**NEW MEXICO
ENVIRONMENT DEPARTMENT**

November 15, 2019

**RE: APPROVAL WITH MODIFICATIONS
RESPONSE TO SECOND DISAPPROVAL WORK PLAN 2015 ANNUAL GROUNDWATER
REPORT COMMENTS
WESTERN REFINING SOUTHWEST INC., GALLUP REFINERY
EPA ID # NMD000333211
HWB-WRG-18-012**

RESPONSE TO COMMENTS
January 28, 2019 Disapproval – Work Plan 2015 Annual Groundwater
Report Comments (Oct. 2018)

FIGURE 2
CHINLE / ALLUVIAL INTERFACE
POTENTIOMETRIC MAP
NORTH

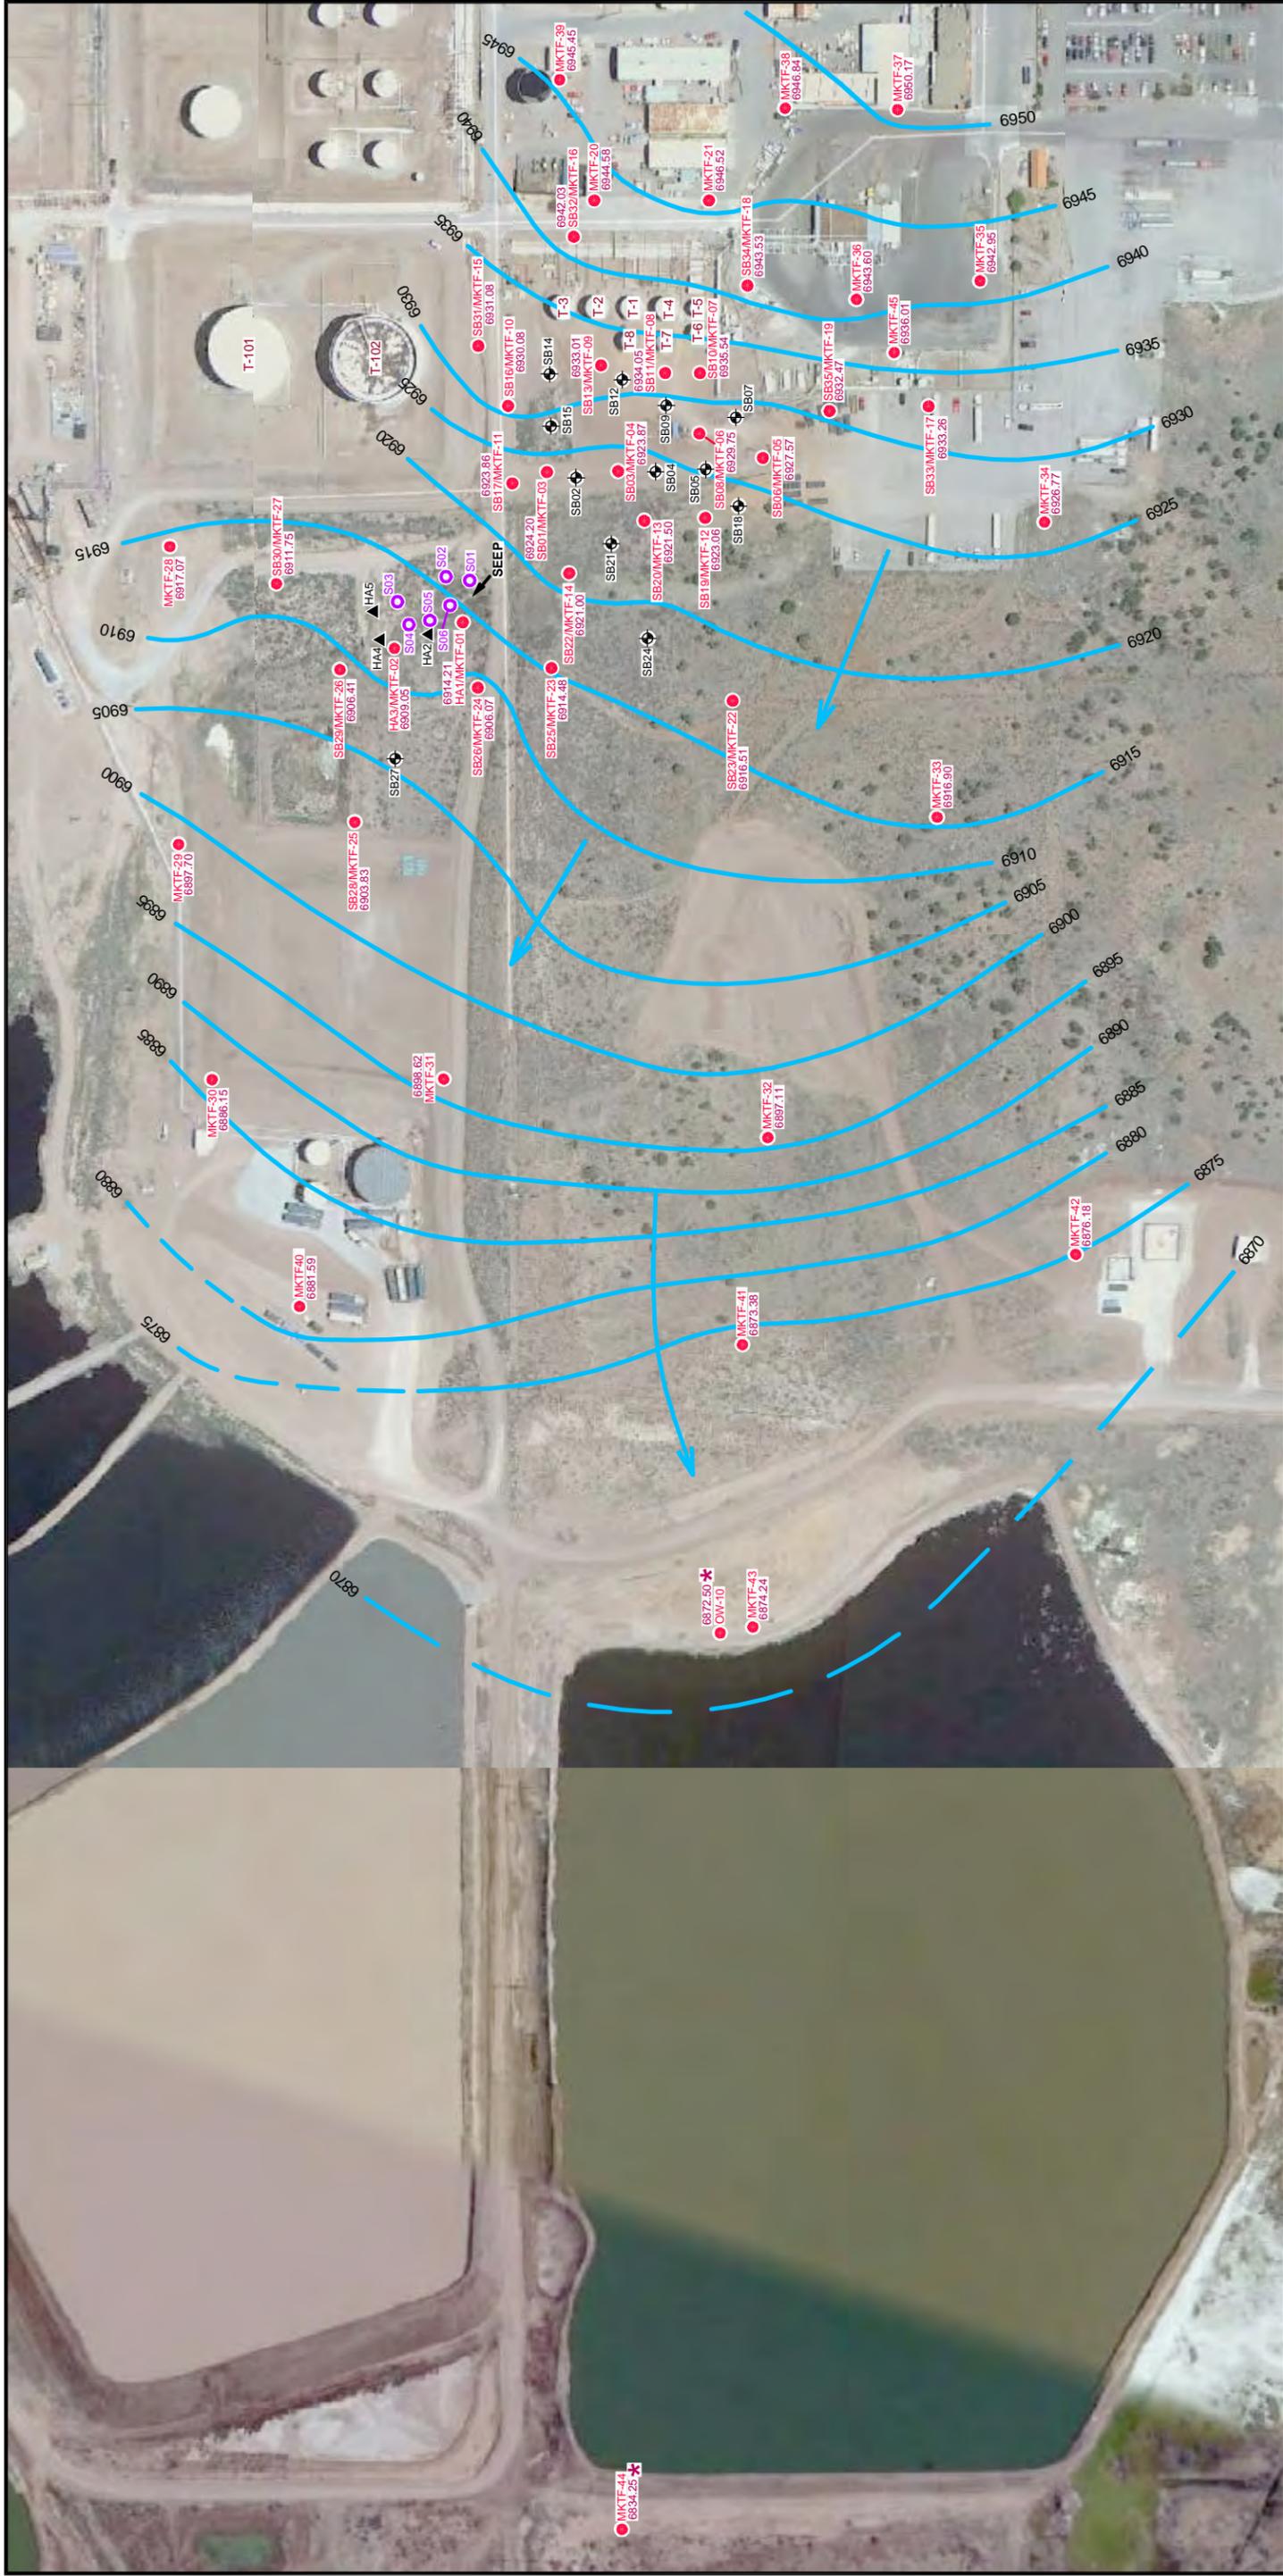
Figure 2, *Chinle / Alluvial Interface Potentiometric Map*, uses the December 2017 groundwater elevation data; however, Figure 2A, *Chinle / Alluvial Interface Potentiometric Map*, uses the March 2015 groundwater data. Figure 2A must be revised to incorporate the December 2017 groundwater elevation data. In addition, Figures 2 and 2A present different maps; Figure 2 presents a northeastern part of the facility and Figure 2A presents entire region of the facility. However, the titles of both figures are identical. Change the titles of the figures for clarity in the revised Work Plan.

Both figures have been revised using data from the August 2018 annual sampling event. The figure titles are also revised to distinguish between the area to the north vs. that to the west.

BORING OW-13

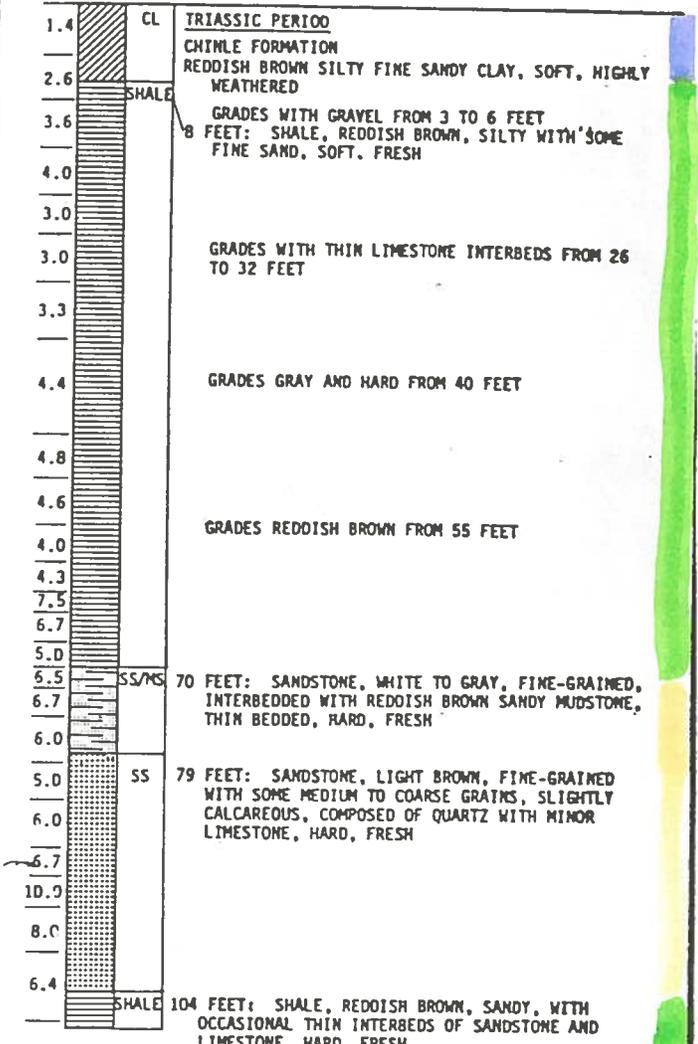
In Section 1, *Introduction*, the Permittee states, "Comment 39 - MTBE concentrations have been slowing [sic] increasing in groundwater samples collected from OW-13. This well was installed in 1981, approximately 37 years ago, and the quality of the well construction is in question. There is a concern the well itself may be acting as a conduit for contamination in the Chinle/Alluvial Interface zone to migrate vertically to the Sonsela Aquifer. It is recommended to plug and abandon well OW-13 and install a new Sonsela well in the same area." Explain the basis for stating that well OW-13 may be a conduit for contaminant migration and the well construction is in question in the revised Work Plan. Well OW-13 must not be abandoned unless sufficient evidence is provided. Replacement of well OW-13 does not address Comment 39. Comment 39 requires the Permittee to investigate the expansion of MTBE plume in the Sonsela formation. Well OW-12 installed in the Sonsela formation is located approximately 800 feet downgradient of well OW-13. MTBE has not been detected to date in the groundwater samples collected from well OW-12. Propose to install a well screened in the Sonsela formation at a location halfway between wells OW-12 and OW-13 in the revised Work Plan.

Additional discussion has been added to Section 4.2 to explain why it is appropriate to plug and abandon OW-13. This is basically due to the thick aquitard that is present in this area above the Sonsela aquifer, which should prevent vertical migration, and an evaluation of the fluid levels in the area suggesting a possible hydraulic connection between the Sonsela and Chinle-Alluvial Interface Zone aquifers. In addition, a new well is proposed between OW-12 and OW-13.
